Access Compliance Report

Public Rights-of-Way

(Pedestrian Signals)

Intersection ID: N/A	Main Street:	Cross Street: N/A	Location: N/A
ADA ID: 2D6B3C320A10	Signal Type: One Push Button-Non APS	Overall Compliance: No	Severity Score: BTN 1: N/A BTN 2: N/A No BTN: N/A
Codes/Mitigation Info/Possible Solution		Field Measurements/Component Compliance

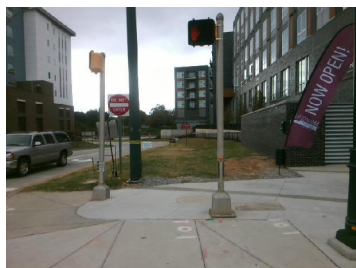
Possible Solutions: Replace Signal Push Button With APS Button on New Post. Remove & Relocate Sign.

PROW/ADA: R209.1, TMUTCD 4e.08, R404.2, R406.2
